RE: 17-DR-2021 | Southdale

The following is our response to the first review comments. We appreciate the time and effort staff has put into the review. We believe the comments and issues are addressed as part of this letter and our re-submittal of the additional requested drawings. Our response follows the COS Staff comments in [BLUE](#).

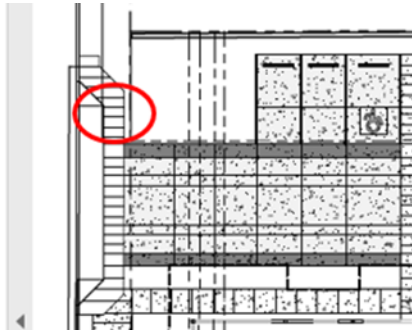
As discussed during review of the preliminary drainage report for case 5-ZN-2020, HEC-1 is not an acceptable method for estimating flows for an area of this size (+/-13 acres). The FCDMC Rational Method must be used. HEC-1 is acceptable for watersheds greater than 160 acres since it tends to underestimate flow for similar watersheds. The HEC-1 results were accepted at the zoning level but must be adjusted for the DRB case. Refer to Section 4-1.504 of the DSPM.

RESPONSE: PER E-MAIL HEC-1 FOR THIS PROJECT IS ALLOWED. PARAMETERS ARE INCLUDED IN REPORT. ANALYSIS WAS REVISED AND Q INCREASED FROM A MORE CONSERVATIVE APPROACH IN THE LAND USE. THE SOILS MAP IS INCLUDED IN THE REPORT. ALSO, AN IMPERVIOUS AREA EXHIBIT WAS CREATED AND SHOWS 50% IMPERVIOUS AREA. HEC-1 WAS UPDATED AND THE NEW 100-YEAR FLOW RATE IS 34 CFS.
